REVIEW OF THE McARTHUR RIVER MINE OPEN CUT PROJECT PUBLIC ENVIRONMENTAL REPORT

By
Professor Wayne D. Erskine
Centre for Sustainable Use of Coasts and Catchments
School of Environmental and Life Sciences
University of Newcastle – Ourimbah Campus
PO Box 127
Ourimbah NSW 2258

July 2006

Figure 1. Bedrock exposed in the bed of the main channel in the upstream anabranching reach. (W.D Erskine photographs).

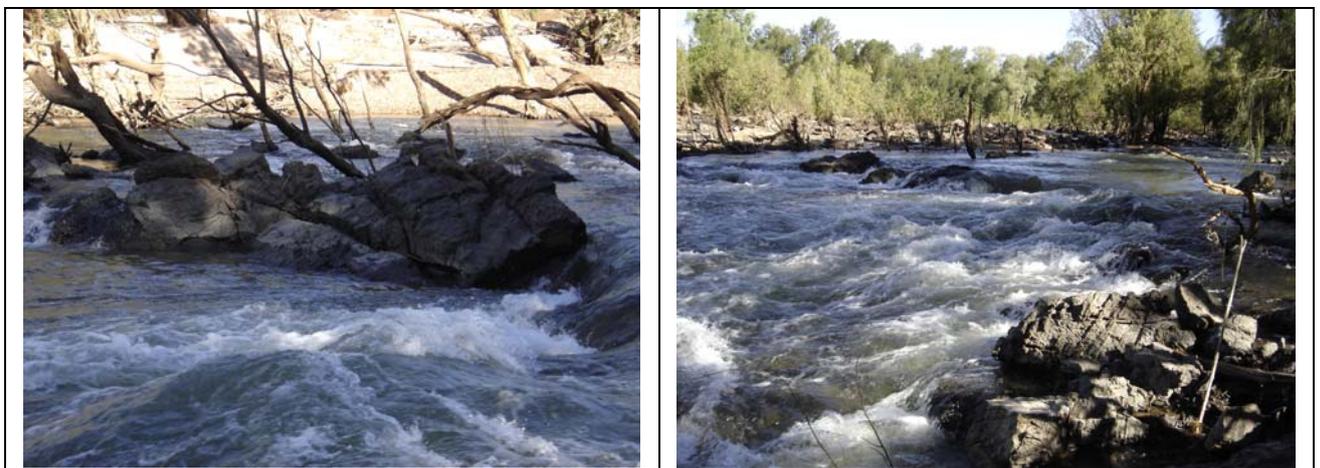
Erskine (2006) expressed concern at the magnitude of the specific stream power/shear stress on the McArthur River under natural and diverted conditions. Erskine (1999) found that when specific stream power exceeds 35 W/m^2 , sand-bed channels usually erode. On the McArthur River, specific stream power often exceeds 80 W/m^2 and hence the channel should be either a very active sand-bed stream with many pockets of rapid bank erosion or contain long sections of channel protected by extensive bedrock bars exposed in the channel boundary. URS (2006) point out that the high specific stream powers calculated under natural conditions occurred where bedrock was exposed in the channel or where some large-scale flow restriction was present. I agree with this assessment following the aerial and on-site inspections of the McArthur River. Figure 1 shows some of the many bedrock bars that are present in the upstream anabranching reach. Figure 2 shows the extensive, steep bedrock rapids at the downstream end of Djurimmini Waterhole. Many trees have had their trunks snapped by the high shear stresses experienced on these rapids and most trees have a marked downstream lean.

Erskine (2006) predicted that upstream progressing degradation will occur upstream of the diversion channel because of the very high specific stream power. The Draft EIS did not discuss whether bedrock was exposed in the channel boundary where the HEC-RAS model indicated that there were very high specific stream powers. Armouring is a natural self-stabilising tendency of rivers which selectively erodes the finer sediment in the bed material and concentrates the coarser sediment on the bed surface. Gravel armour layers produced by bed degradation are monolayers that coat and hence protect the finer underlying sediment from erosion. The Draft EIS did not investigate armour layers. My initial concerns have been reduced because bedrock is exposed in the channel bed at sites of high specific stream power and a significant gravel fraction is present in many sections of channel in the upstream anabranching reach (see above).

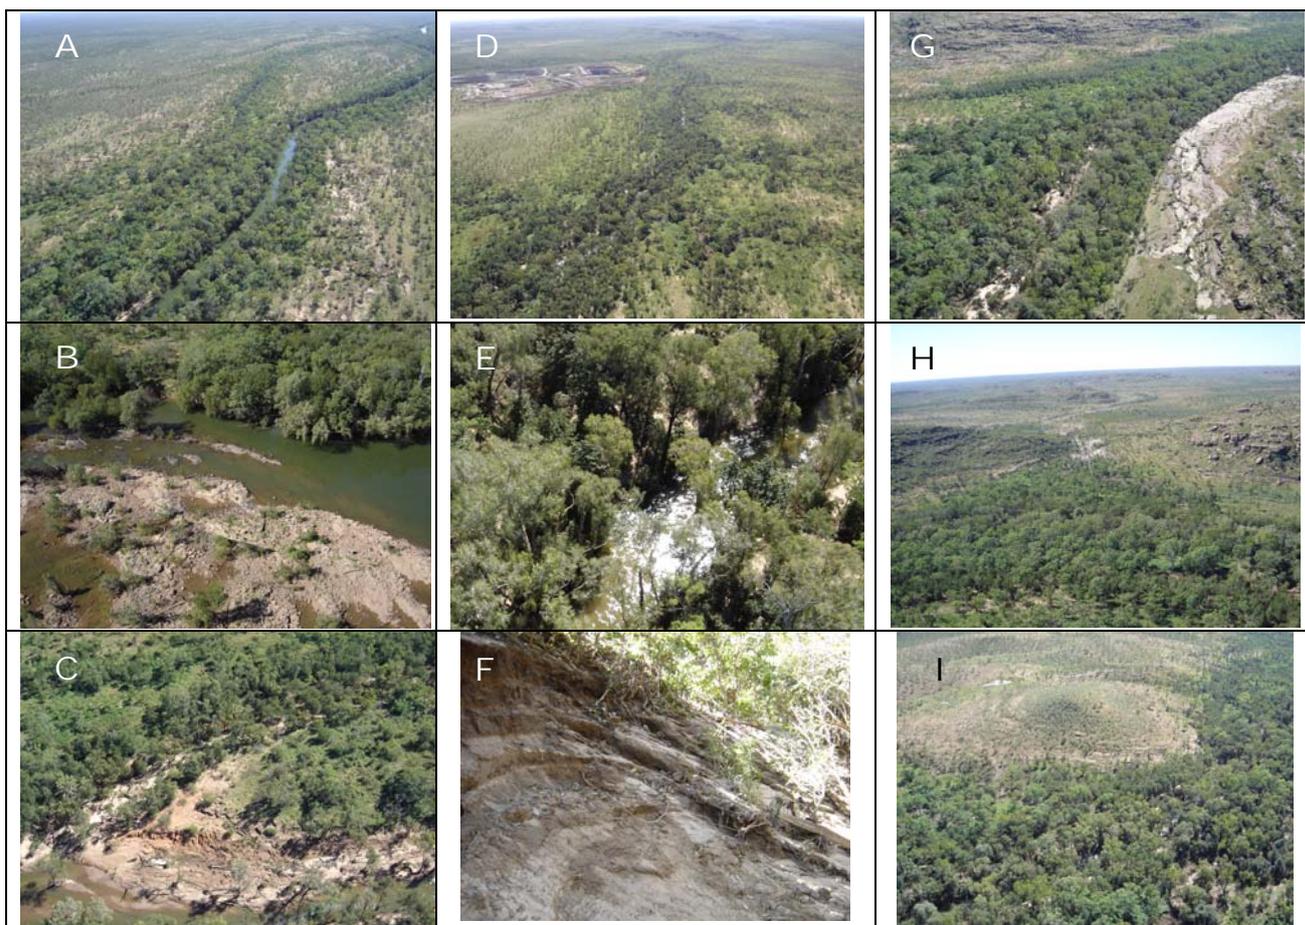
While URS (2006) concluded that the channel of the McArthur River was stable upstream of the entrance to the diversion channel in the anabranching reach, there are pockets of bank erosion (Figure 4C). These pockets seem to occur where there are gaps in the riparian vegetation due to flood disturbance and/or grazing damage or where there are channel bifurcations around islands or where there are locally steeper sections over bedrock bars. The channel is not as active as originally expected (Erskine, 2006) because

of the often dense riparian vegetation and the multiple bedrock bars. Nevertheless, the channel is also not as stable as suggested in URS (2006).

justify calling the existing channel near the mine as stable (see URS, 2005a, Appendix K, p. K-24). The representativeness of a single piece of site specific data is always a concern. By itself, it is not helpful. As noted in URS (2006), aerial inspection of the upstream anabranching reach revealed numerous bedrock bars in the bed of the main channel and occasional sections of bank erosion (Figure 4C). Furthermore, high parts of the floodplain were also eroded by rilling and gulying and appeared to be associated with overgrazing of dispersible/slakeable soils (Figure 5).
